Subject: NRC 10 CFR 72 Certificate of Compliance No. 1008, TAC L22019
License Amendment Request 1008-1

Holtec International hereby submits License Amendment Request (LAR) 1008-1, Revision 0, proposing certain amendments to 10 CFR 72 Certificate of Compliance (CoC) No. 1008 and its supporting Topical Safety Analysis Report for the HI-STAR 100 System. Information describing and justifying the changes requested by this LAR is contained in the attachments listed below. In preparing this amendment request package, we have intentionally included non-mandatory material, such as marked-up and final versions of the CoC, and proposed Topical Safety Analysis Report (TSAR) changes. This non-mandatory information adds to the overall bulk of the submittal, but should greatly facilitate the NRC staff's review effort. A final Revision 11 of the HI-STAR 100 TSAR will be submitted within 90 days of the date of publication of the final rulemaking that issues the CoC amendment.

Attachment 4: Drawing Revision Summary, Revised Holtec Design Drawings, and New Dresden Unit 1 Damaged Fuel Canister and Thoria Rod Canister Drawings.

Attachment 5: Proposed Revision 11 Changes to the HI-STAR Topical Safety

FIGURE 2.1.6; ILLUSTRATIVE BURNUP AND COOLING TIME FOR DECAY HEAT AND RADIATION SOURCE TERMS

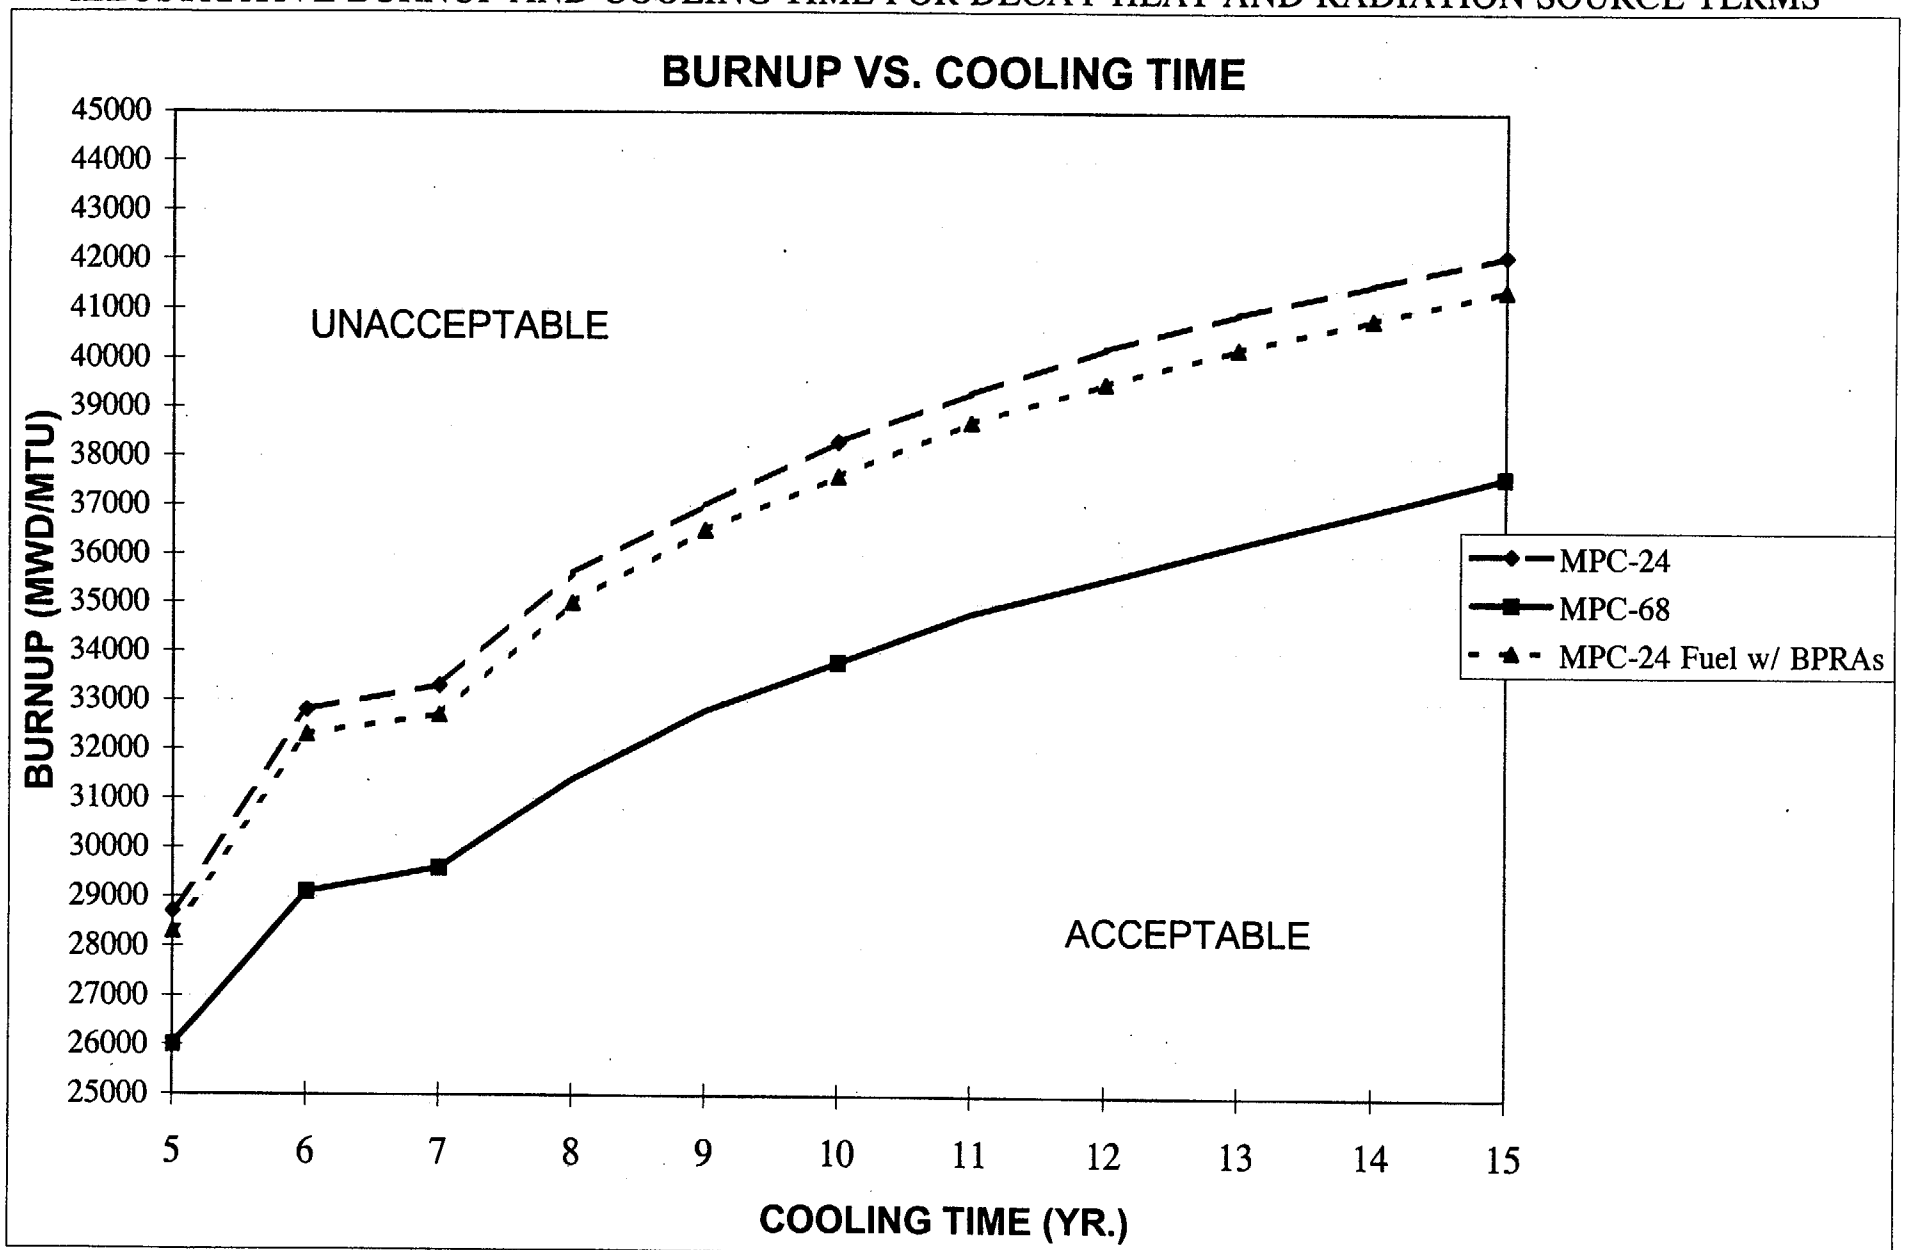
m. Figure 2.1.6 is revised to add a curve for PWR fuel containing BPRAs.

3.J.4 Analysis of Upper Spacer End Plate for PWR Spacers

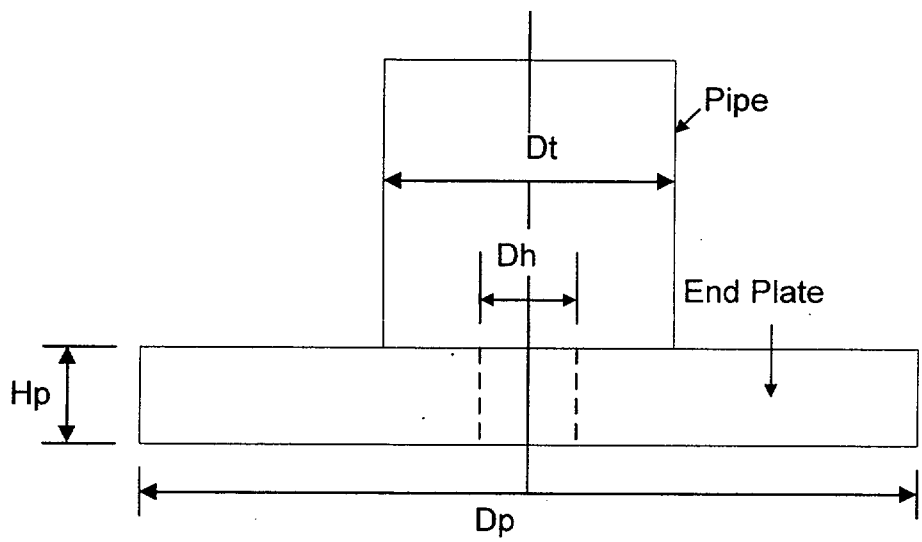
f. Appendix 3.J is revised to analyze the modifications to the upper fuel spacers for the MPC-24 (Design Drawing 1396, Sheet 6).

Some PWR fuel types are not supportable by the current upper spacer design having a simple pipe extension. To insure that all PWR fuel types are captured, an end plate having sufficient diameter is welded to the end of the pipe to extend the contact area. This section of the appendix addresses the stress analysis of the end plate to insure that it performs as desired under a handling accident that results in a direct impact of the fuel assembly onto the end plate. The configuration is shown below:

FIGURE 7.1.3; HI-STAR 100 SYSTEM MPC CLOSURE WELD DETAILS

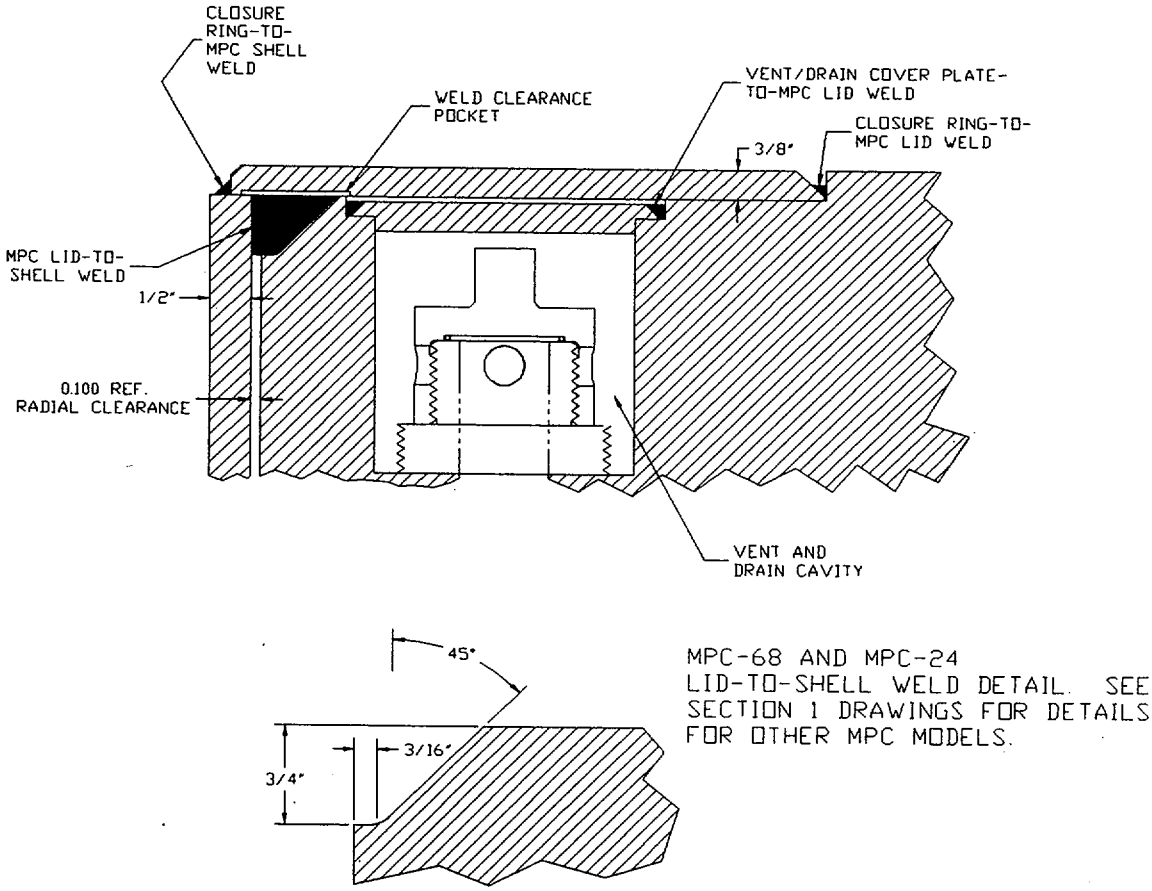
f. Figure 7.1.3 is revised to remove the call-outs of the closure ring weld size and to correct the size of the MPC lid-to-shell (LTS) weld. A clarifying note is added regarding the LTS weld.
